# Product Change Notification

<b>Date Issued :</b>	February 14, 2025	<b>PCN Number :</b>	516559
<b>Reason for Change :</b>	Obsolete		
<b>Description of Change :</b>	This notification is to inform you about the obsolescence of parts referenced in this notice. Please connect with your Molex Sales Engineer for additional queries related to possible alternative solutions.		
<b>Reason for Short Notice :</b>	Supplier Constraints		
<b>Planned Implementation Date :</b>	February 02, 2026		
<b>Recommended replacement parts :</b>	Please see the attached replacement parts list .xls file.		
<b>Last Time Buy Date for Obsolete Parts :</b>	October 01, 2025		
<b>Last Time Ship Date for Obsolete Parts :</b>	December 30, 2025

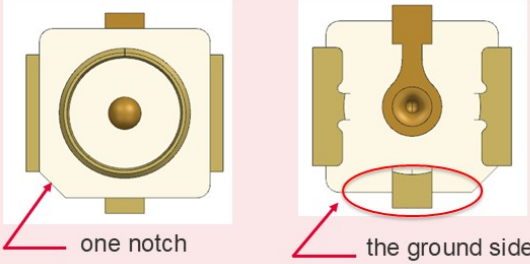
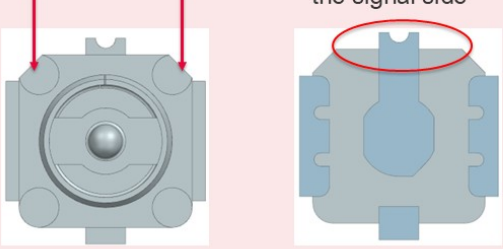
Before (obsolete one)	After (similar replacement) with Feature Form Difference
MCRF PCB 734120110, 734120114	MCRF PCB 734123150 (MLQ 40K pcs) MCRF PCB 734123152 (MLQ 20K pcs)
<ul style="list-style-type: none"> <li>734120110/-0114 has one notch on the ground side.</li> </ul>	<ul style="list-style-type: none"> <li>734123150/52 has two notches on the signal side.</li> </ul>

Before (obsolete one)	After (similar replacement) with Feature Form Difference
MCRF PCB 734120110, 734120114	MCRF PCB 734123150 (MLQ 40K pcs) MCRF PCB 734123152 (MLQ 20K pcs)
<ul style="list-style-type: none"> <li>734120110/-0114 has 3 Pads</li> </ul> 	<ul style="list-style-type: none"> <li>734123150/52 is with 4 Pads</li> </ul>

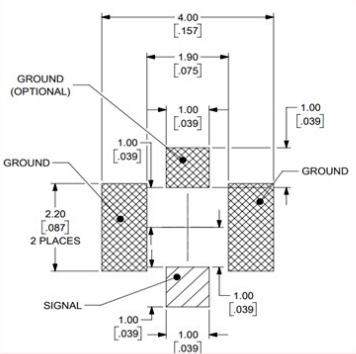
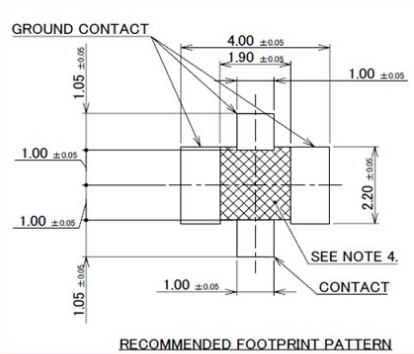
- **Change Description:** Molex outsourced cable/MCRF existing supplier, sent announcement on Oct.29<sup>th</sup> 2024, mentioned they will stop CMJ (MCRF PCB) product line by end of 2024. The affected Molex FG PN is attached. Molex created a similar spec 734123150/3152 as replacement. During the OBS PCN process, material vendor has prepared the safety stock of components to support customers the change.

- **Product Impact**
  - 734123150 is compatible with Feature Form Differences
  - Compatible with Feature Form Differences 4 Pads, two notches on the signal side, Package MLQ 40K pcs and 20pcs options

- 734120110/-0114 has one notch and 734123150 has two notches on the signal side
  - 734123150 is with 4 Pads
  - 734123150 package 5K pcs a reel. MLQ 40K pcs
